**SITE PLAN REVIEW SHEET
ENVIRONMENTAL VARIANCE REQUEST ONLY**

CASE: SP-2022-0167D (W/R SP-2020-0307D)

PROJECT NAME: 1703 N. River Hills Road Marina Reconstruction

Re: Engineering Summary Letter
1703 N. River Hills Road Marina Reconstruction SP-2022-0167D
Application for a variance to

ATTACHMENT 3
FUEL SYSTEM LAYOUT SHEET

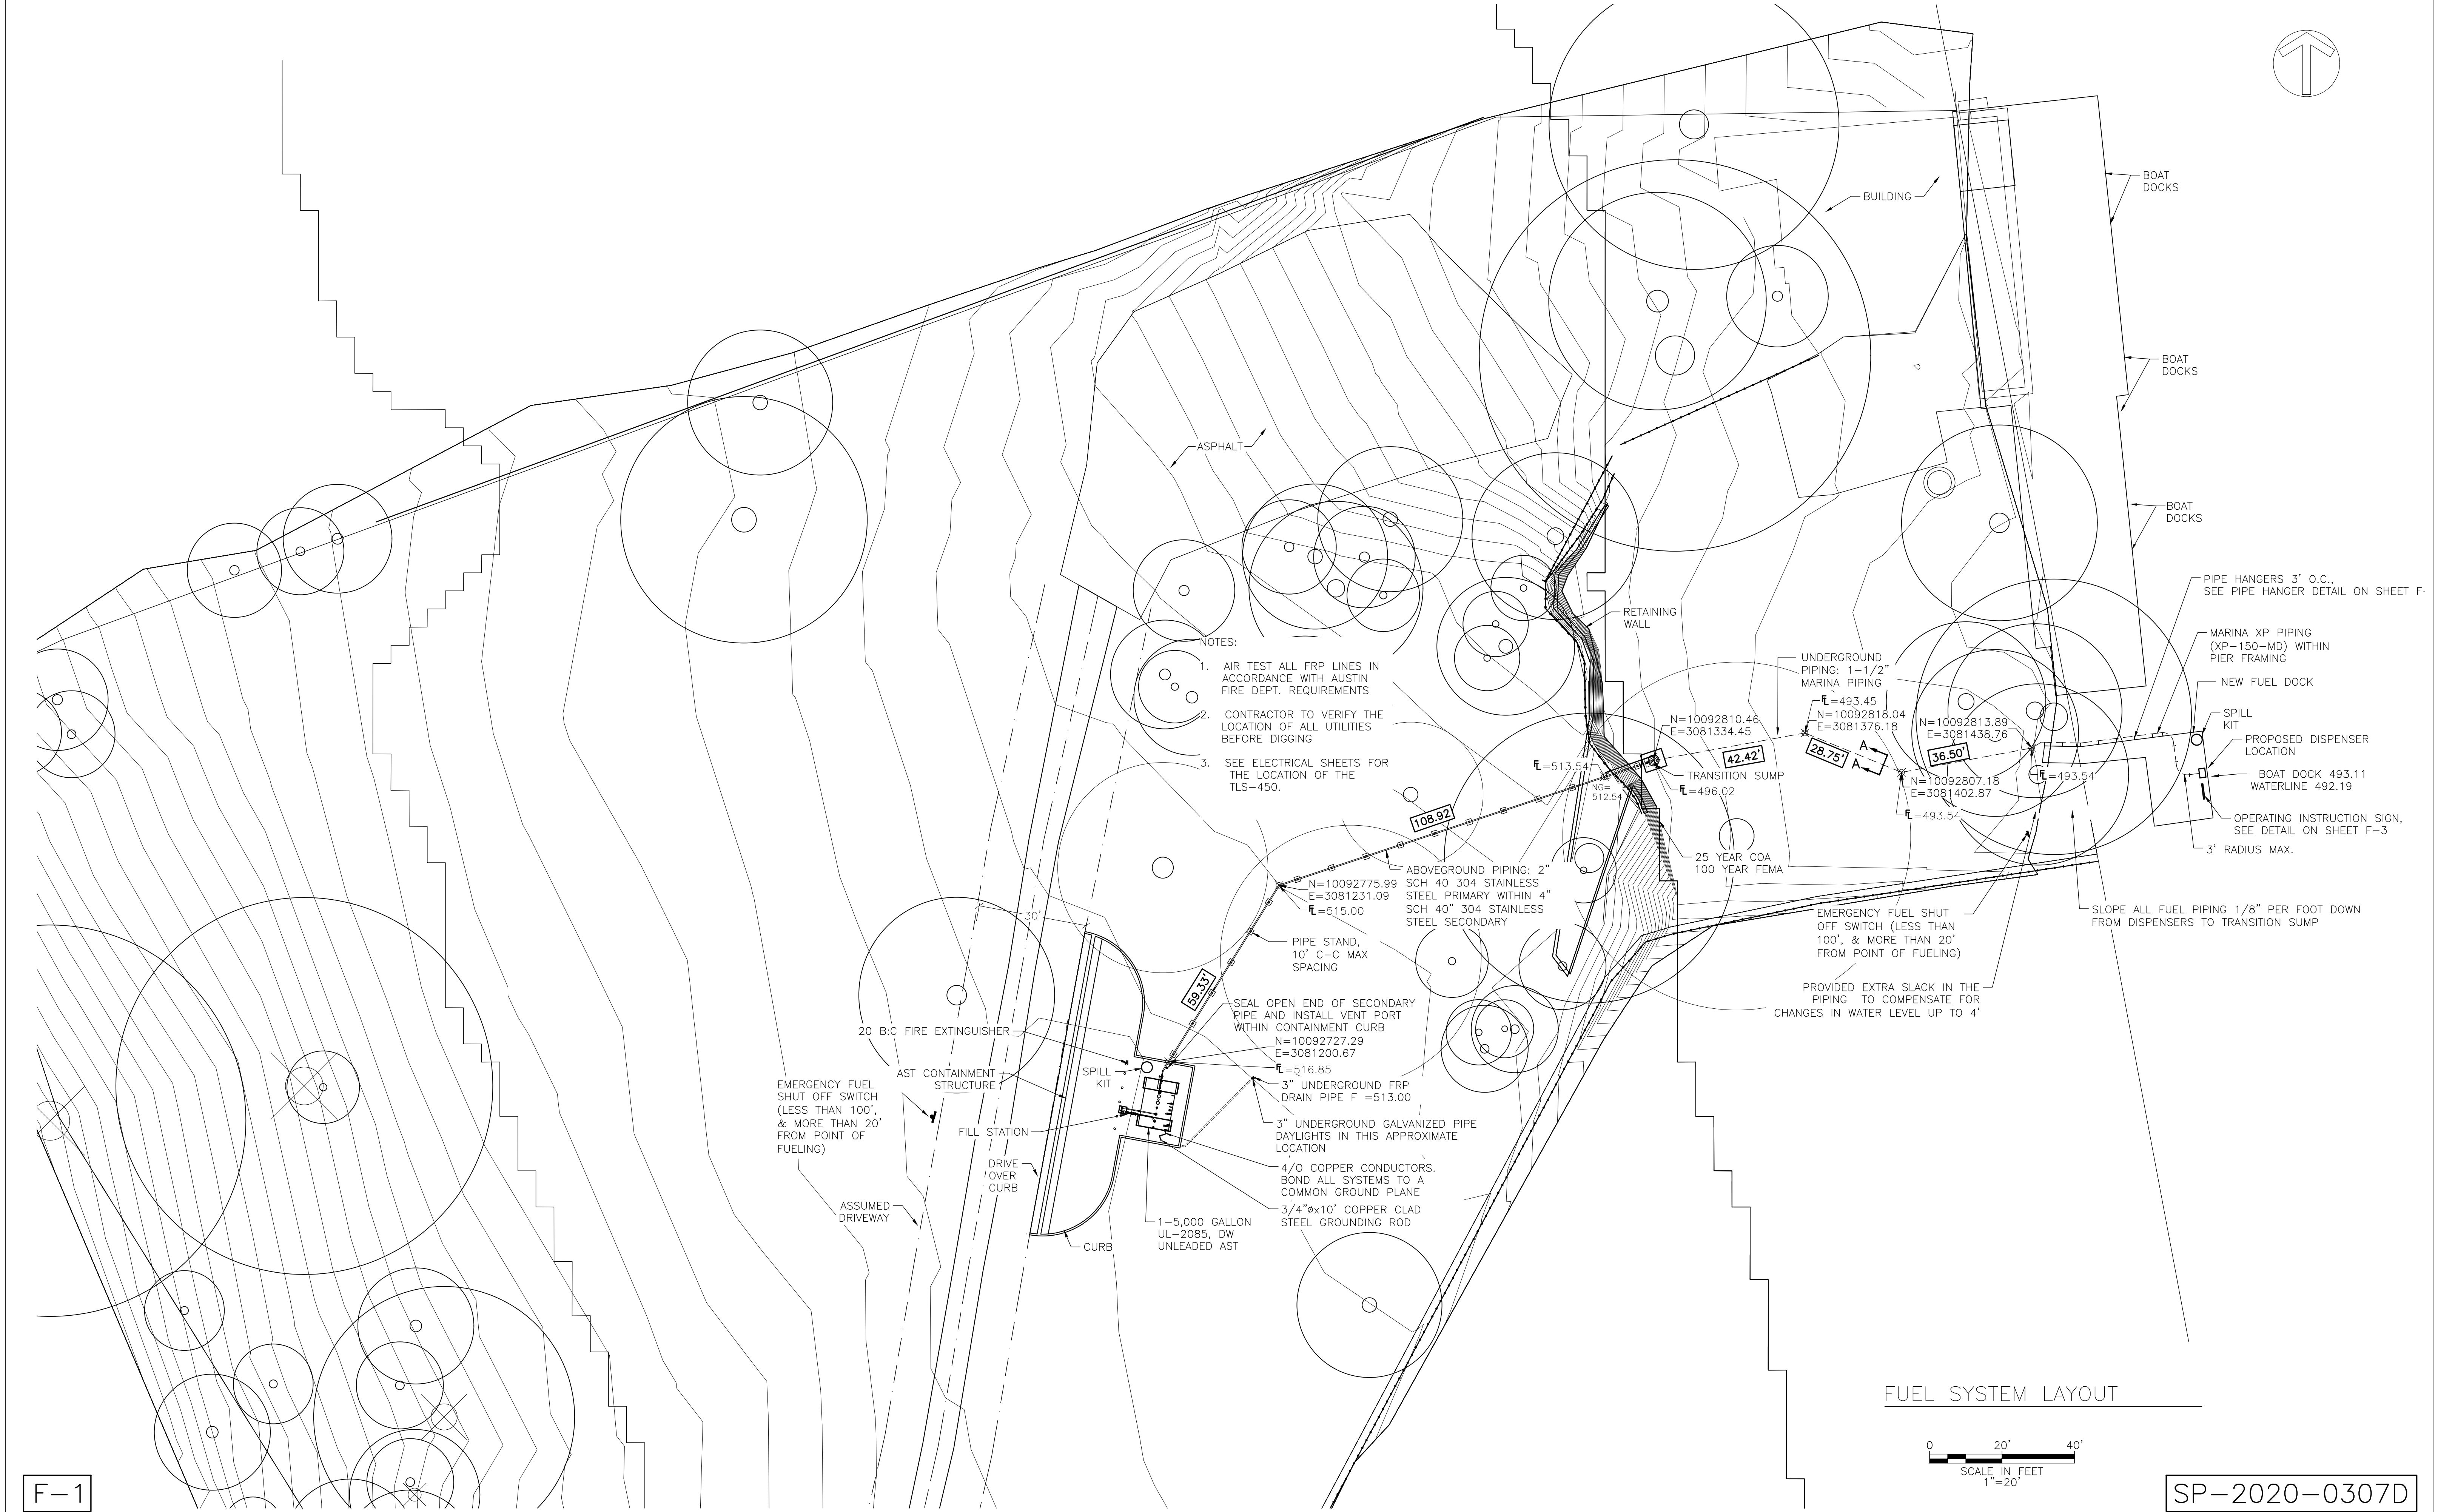
Land-based refueling subject to current Code is required to provide water quality ponds and HMIs (hazardous material interceptors) designed to prevent petroleum products and other contaminants from leaving the site and entering waterways. In contrast, any petroleum spills resulting from the proposed

The applicant's decision will not provide greater overall environmental protection than is achievable without the variance. On the contrary, it is staff's view that fuel dispensing operations will decrease environmental protection through spills at the pump and discharges of fuel and oil into the water from the queuing boats.

No Due to the toxicity of gasoline fuel, any amount of leakage is a harmful environmental consequence. It is not possible to provide adequate safety measures, such as HMIs, when fueling over the water. Moreover, boats queuing at the fueling station will add to the fuel and oil discharged at the site.

YES. The ability to install gas service at the marina should improve the water quality of the lake. Instead of untrained owners gassing up a boat multiple times for a day of boating, a trained employee can fill-up each boat only once for the same day of boating. It should result in fewer gas spills into the lake. Additionally, the gas tank and line are designed to contain spills occurring at the pump or in the fuel line to the marina, and the facility will execute a Spill Response Plan if a spill occurs.

RAW WATER INTAKE FOR TRAVIS COUNTY WATER CONTROL AND IMPROVEMENT DISTRICT #20

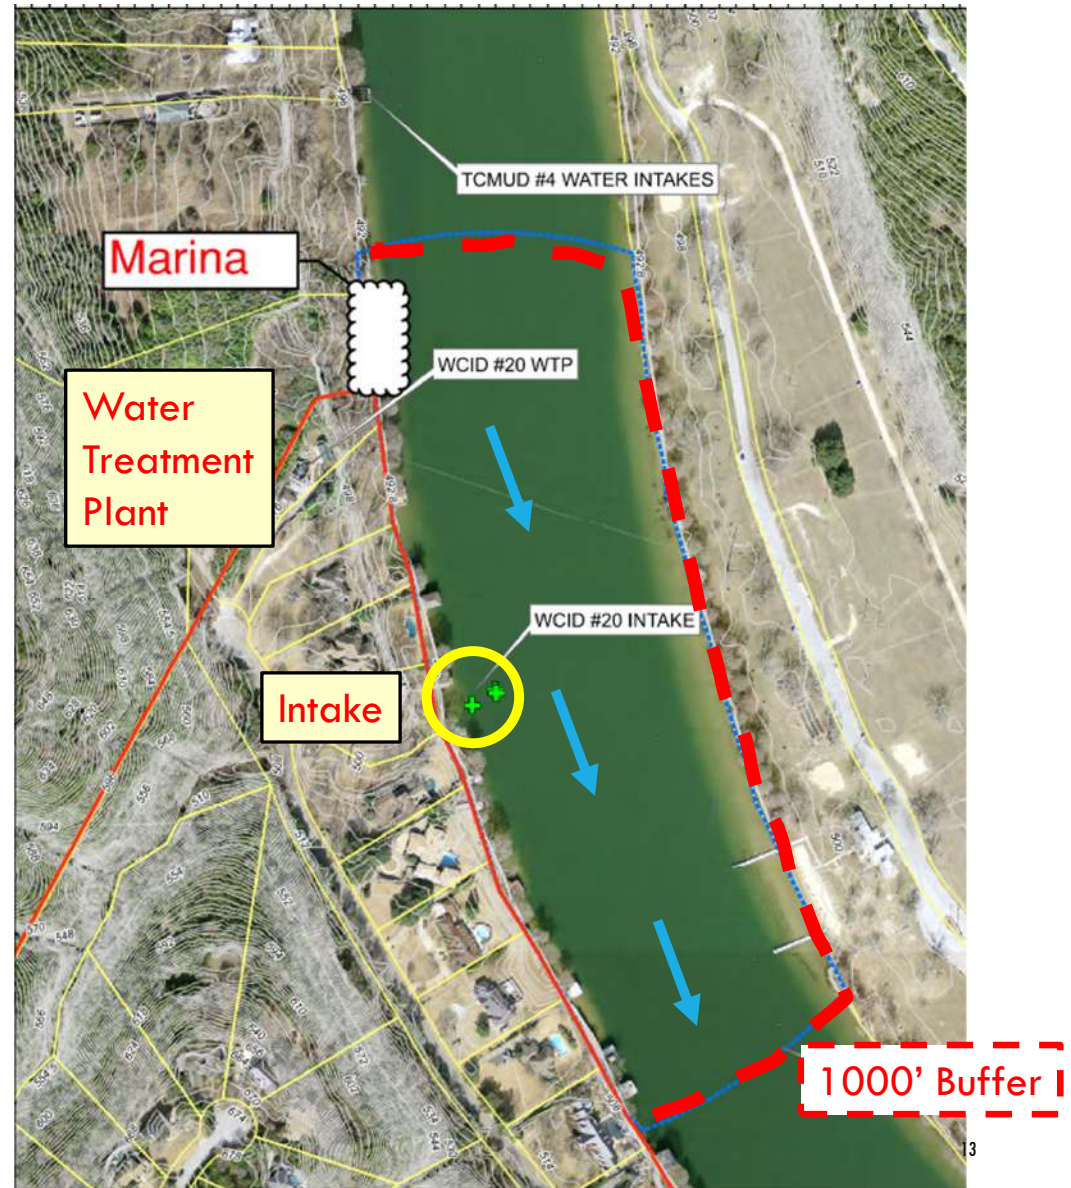
Travis County Water Control and Improvement District (WCID) #20 has a water treatment plant (WTP) on the lot adjacent to the variance site.

The raw water intake for the WTP is approximately 800 feet downstream of the variance site.

VARIANCE REQUEST 2

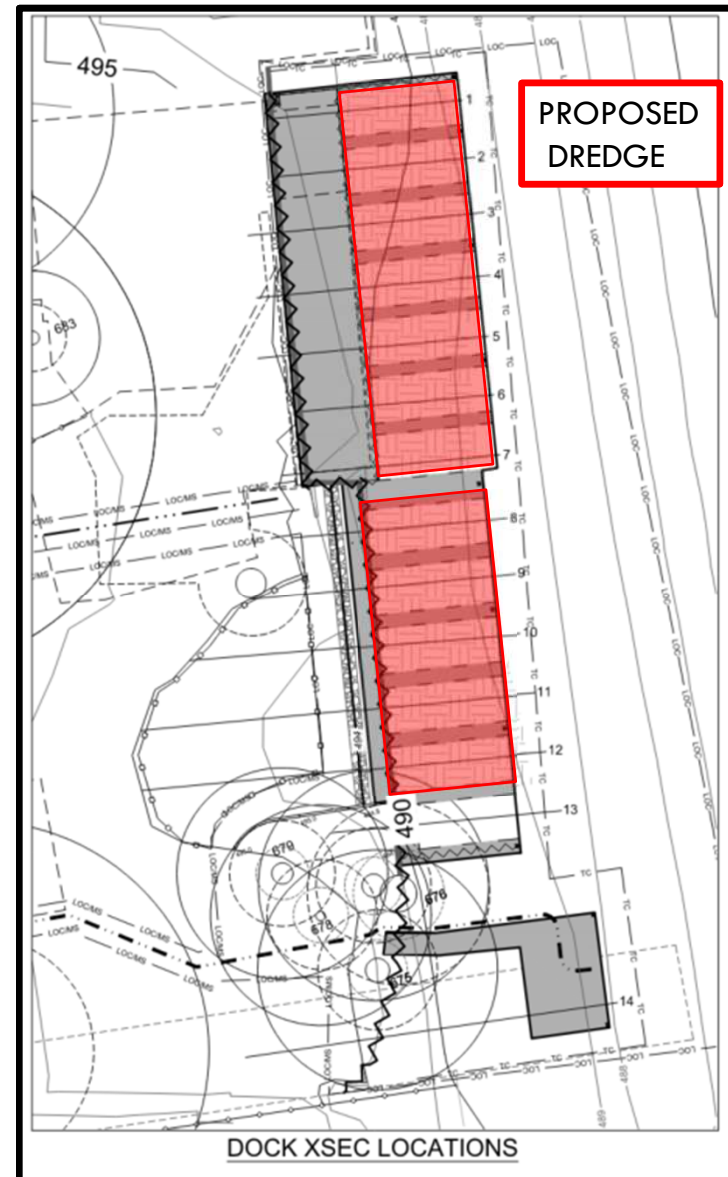
- Existing marina built prior to 1965
- Replace/Rehabilitate
 - Existing 21 slips
 - Proposed 16 code-compliant slips
 - Within the existing footprint

VARIANCE REQUEST 2

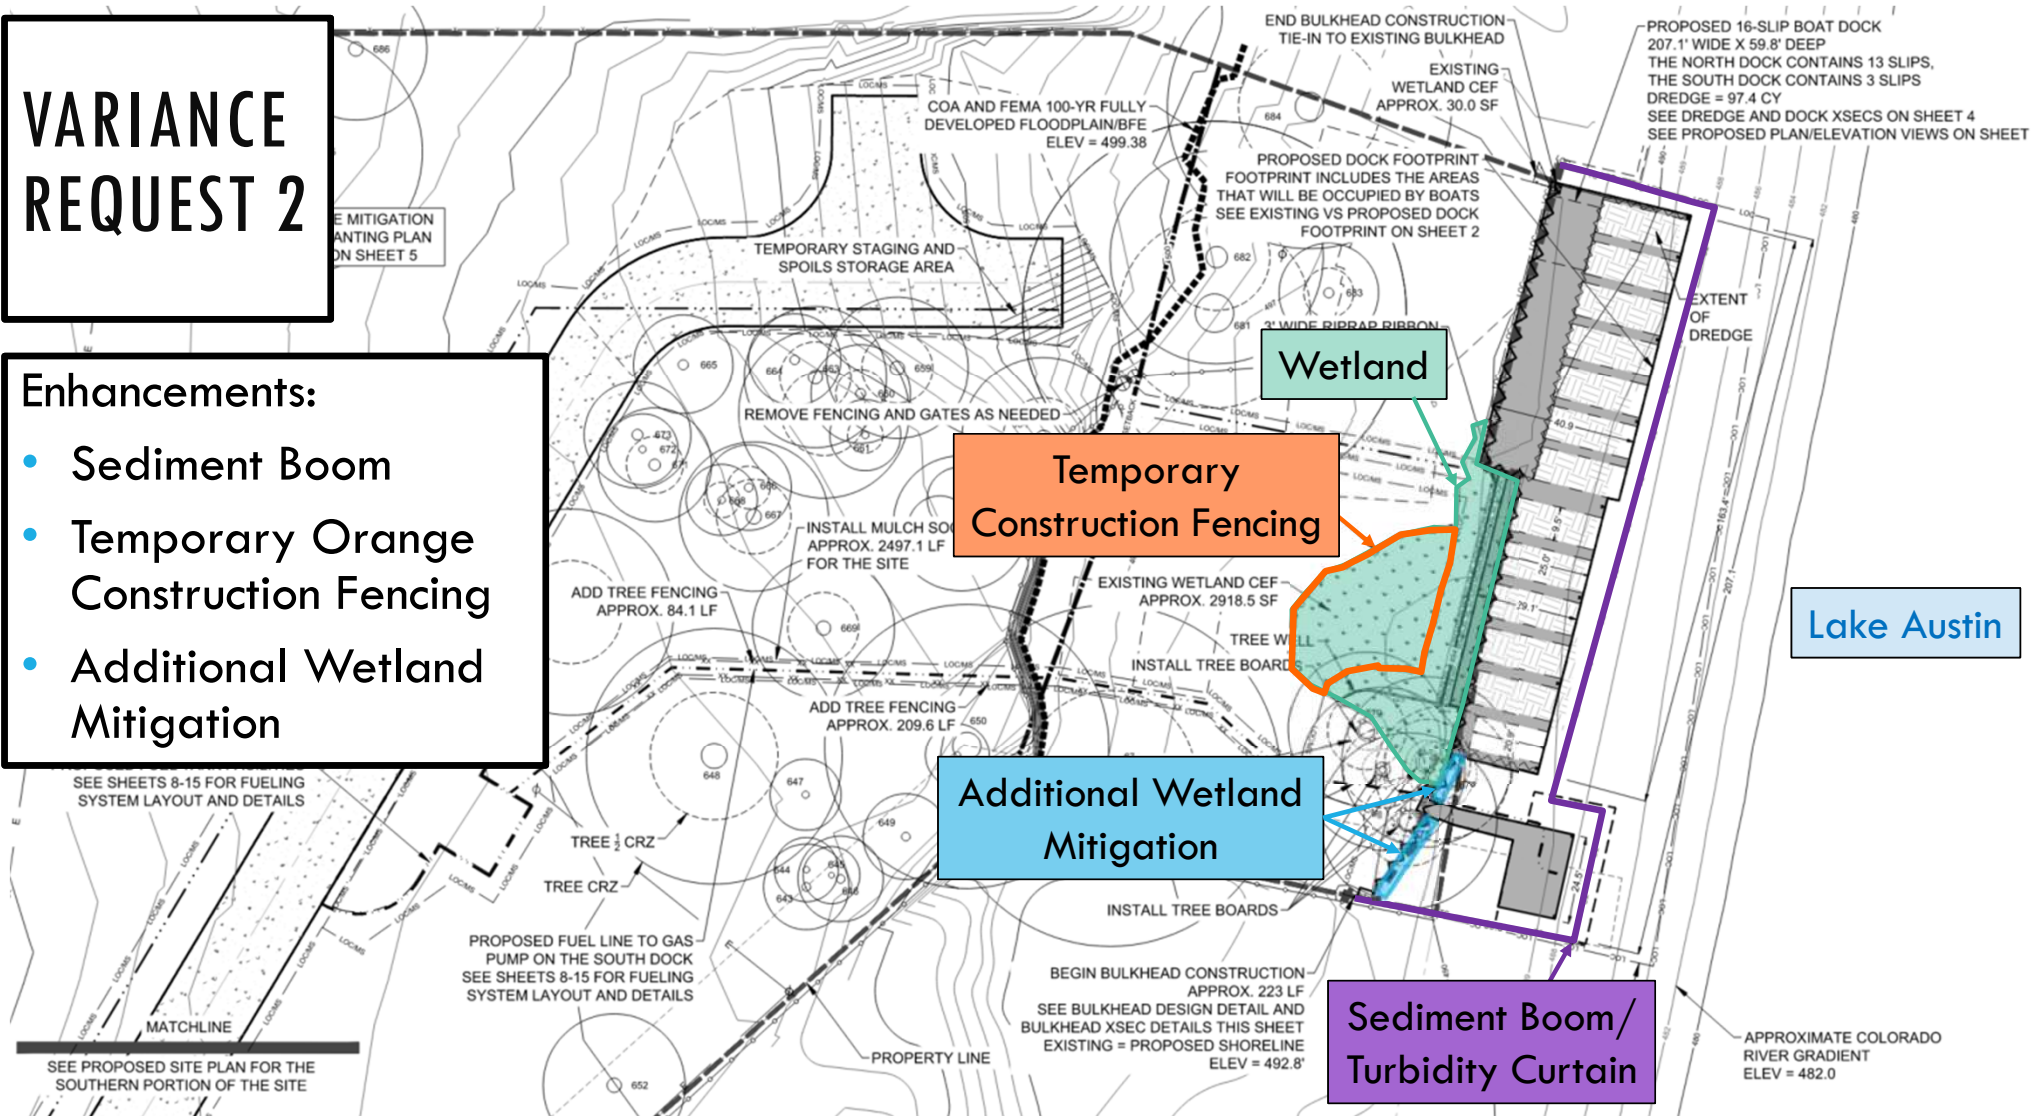
- Sediment Boom
- Temporary Orange Construction Fencing
- Additional Wetland Mitigation
